The Commission has issued the enclosed Amendments Nos. 118 and 122 to Facility Operating Licenses Nos. DPR-44 and DPR-56 for the Peach Bottom Atomic Power Station, Units Nos. 2 and 3. These amendments consist of changes to the Technical Specifications (TSs) in partial response to your application dated November 18, 1985.

PEACH BOTTOM ATOMIC POWER STATION, UNIT NO. 2

Amendment No. 118  
License No. DPR-44

SAFETY EVALUATION BY THE OFFICE OF NUCLEAR REACTOR REGULATION  
SUPPORTING AMENDMENT NO. 118 TO FACILITY OPERATING LICENSE NO. DPR-44 AND  
AMENDMENT NO. 122 TO FACILITY OPERATING LICENSE NO. DPR-56  
PHILADELPHIA ELECTRIC COMPANY, ET AL.  
PEACH BOTTOM ATOMIC POWER STATION, UNITS NOS. 2 AND 3  
DOCKETS NOS. 50-277/278

**FIGURE 6.2-1**

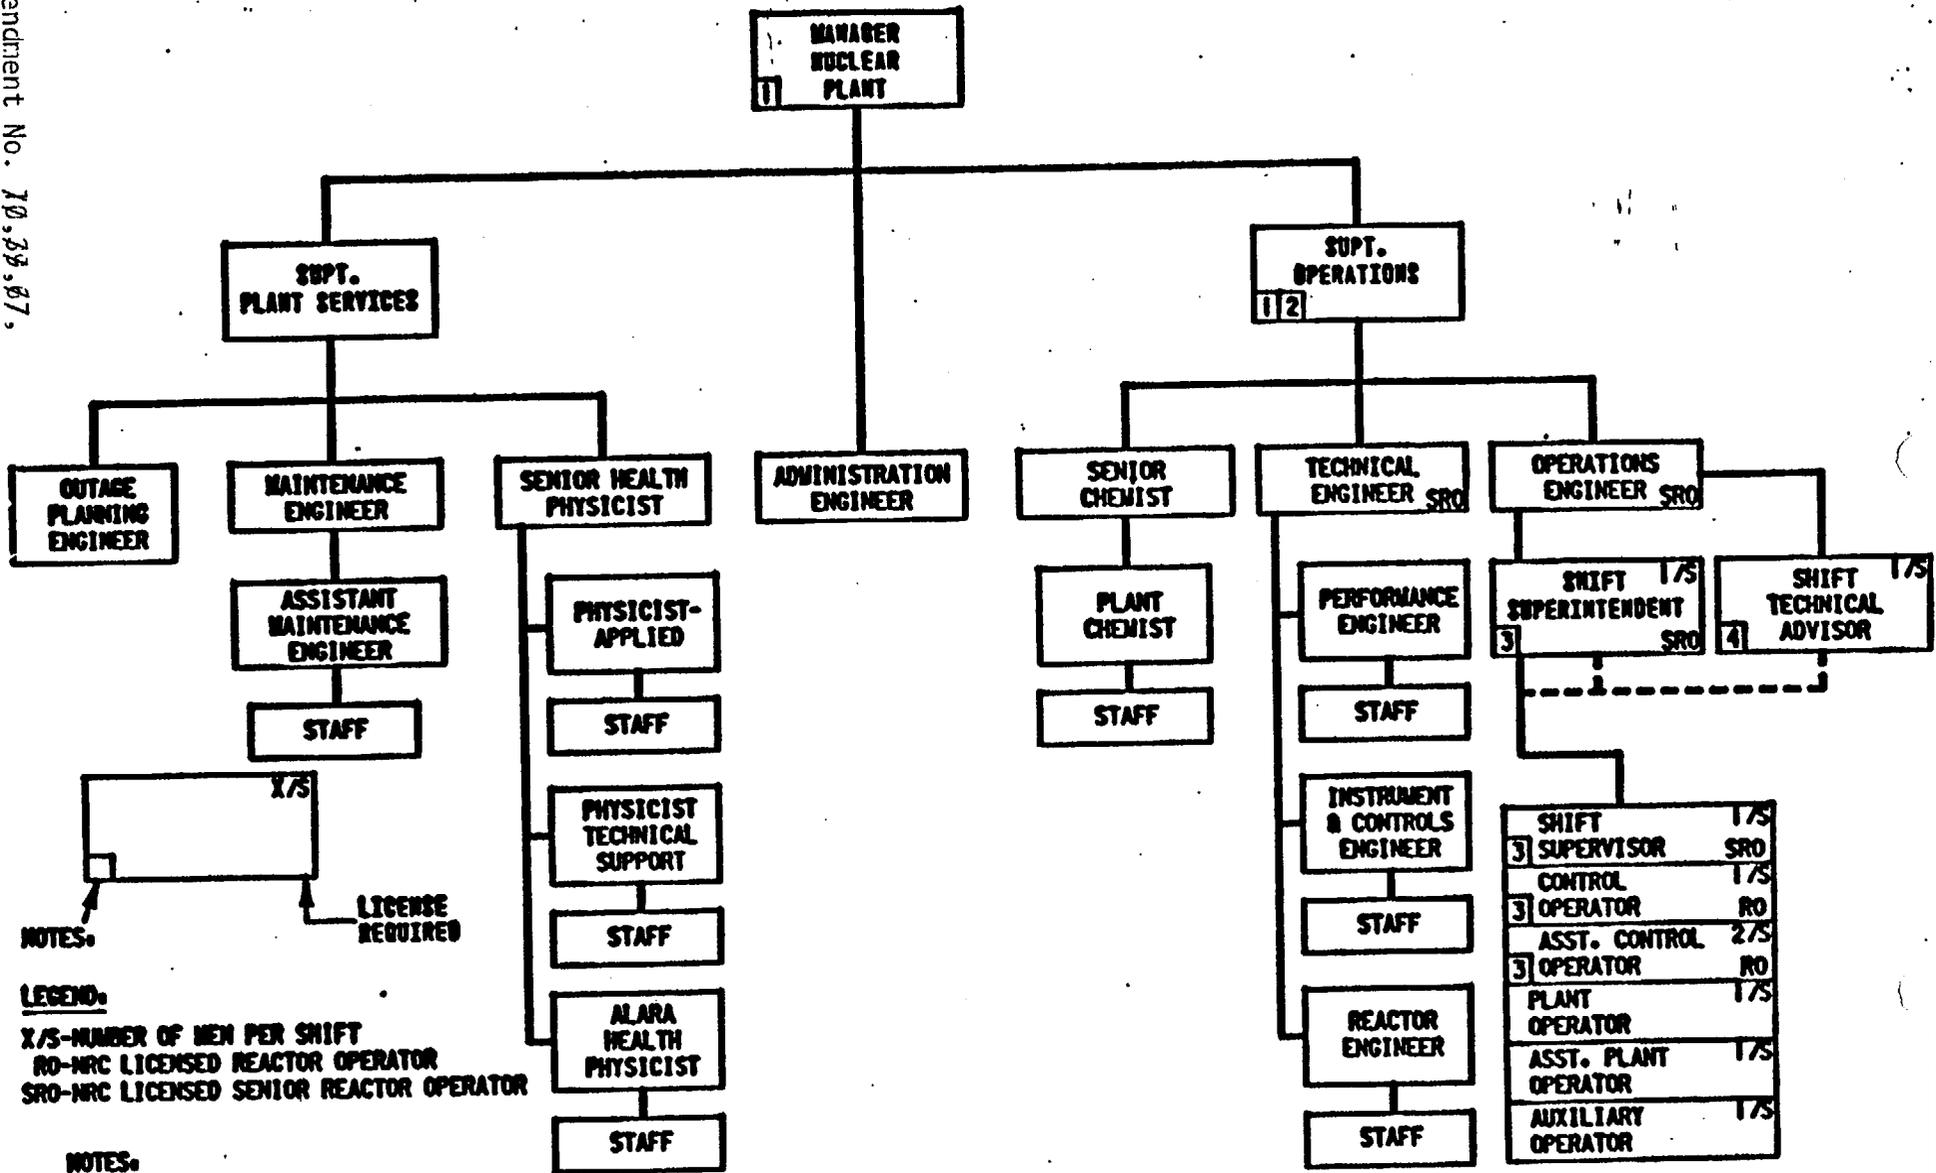
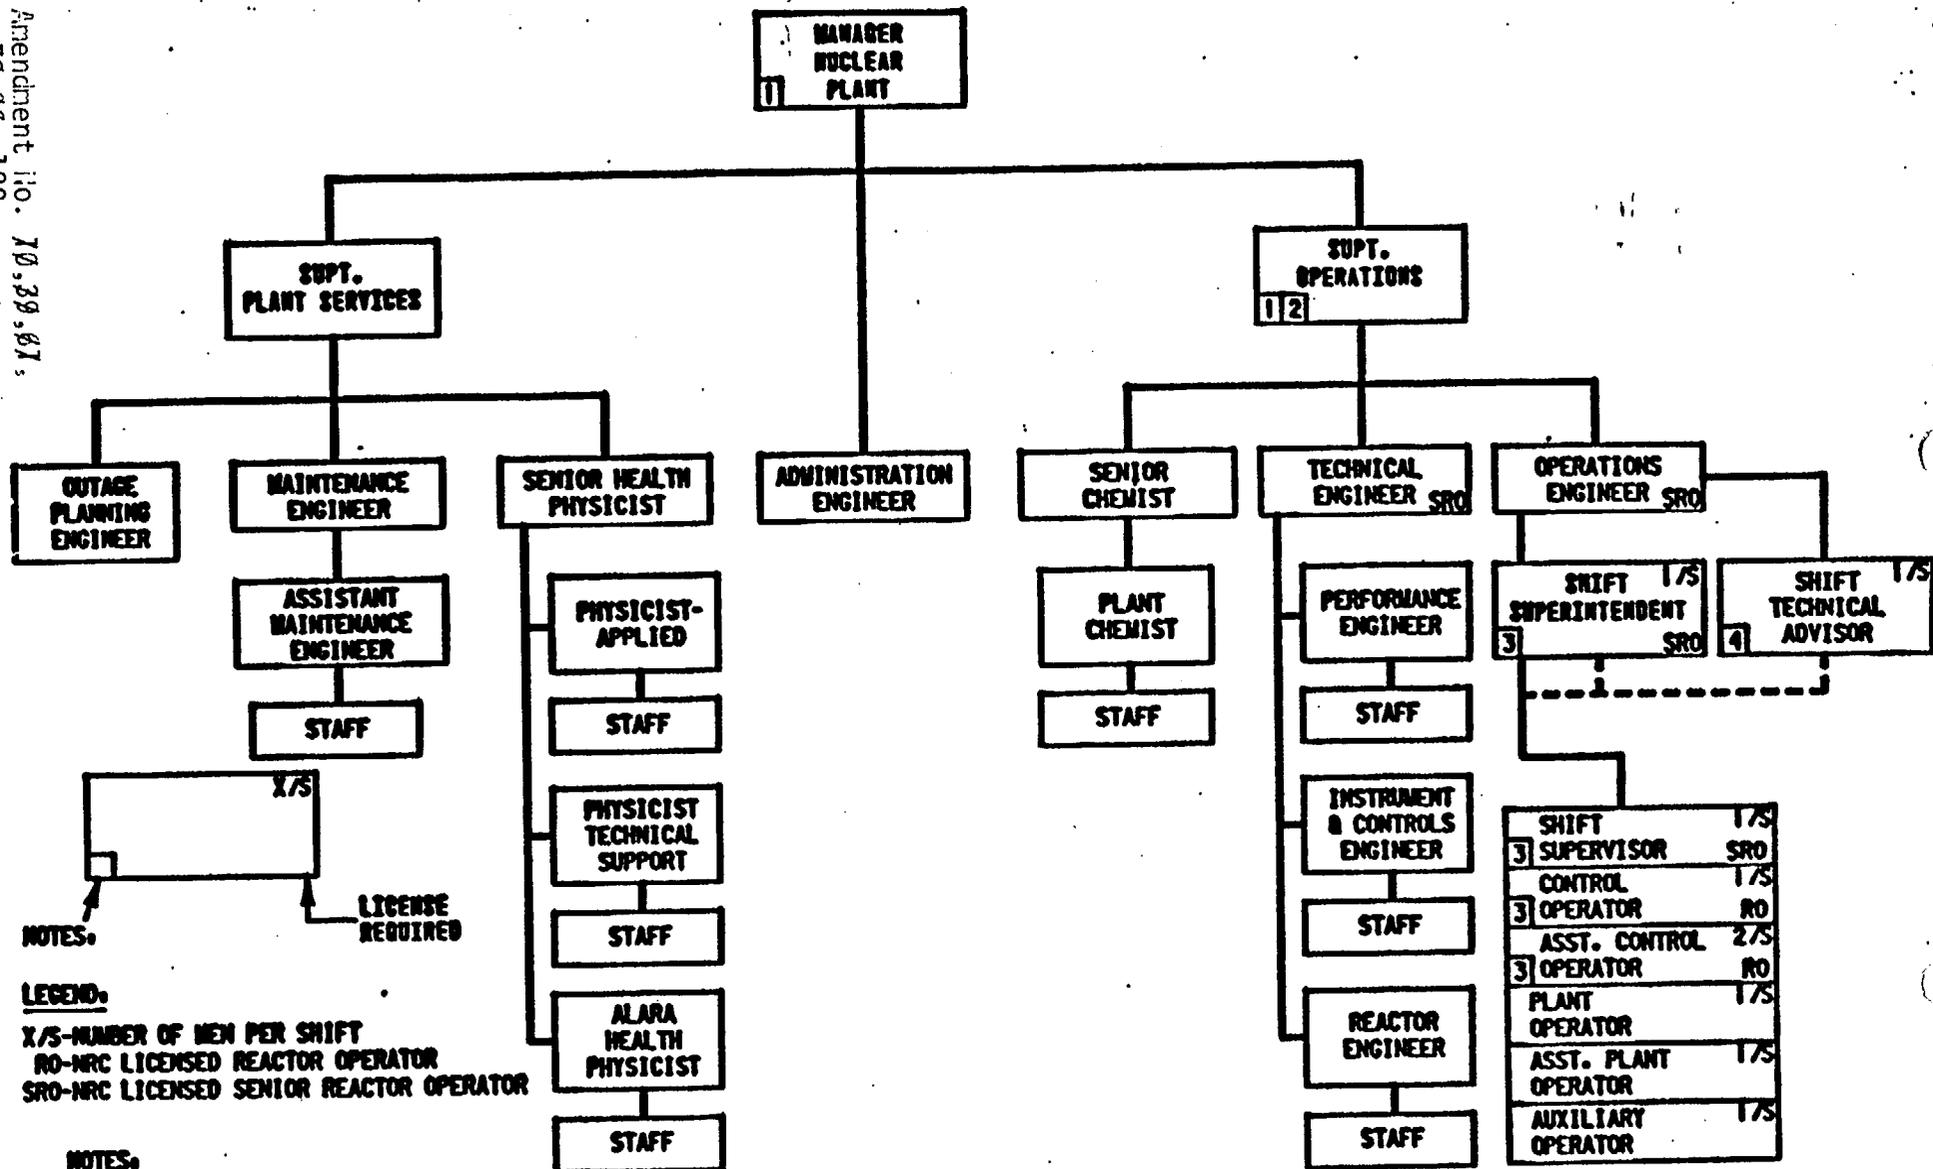
The proposed revisions to Figures 6.2-1 and 6.2-2 of the TS would change the title of "Station Superintendent" to "Manager-Nuclear Plant" and would create two new positions: Superintendent-Operations and Superintendent-Plant Services at the superintendent level to handle the plant management responsibilities previously handled in a single line organization through an Assistant Superintendent to the Station Superintendent. The Superintendent-Operations would manage the Senior Chemist, Technical Engineer and Operations Engineer. The Superintendent-Plant Operations would manage the Outage Planning Engineer, Maintenance Engineer and Senior Health Physicist.

The proposed changes to the organization charts on Figures 6.2-1, 6.2-2 and 7.1.1, and to pages 243, 246, 247, 248 and 254 of the TS would reflect the following title changes: "Station Superintendent" to "Manager-Nuclear Plant" and "Results Engineer" to "Performance Engineer." These represent only changes in nomenclature and the responsibilities of these two positions remain unchanged.

In addition to the proposed changes previously described in Figure 6.2-1, the Management Organization Chart is revised to depict the splitting of the Generation Division into separate Fossil/Hydro and Nuclear groups, and the formation of a Nuclear Services group. The NRC was previously informed of this reorganization in letters dated April 4, 1983 and May 29, 1984.

The staff finds this proposed change to be acceptable since it conforms to Section 13.1.1 of the SRP.
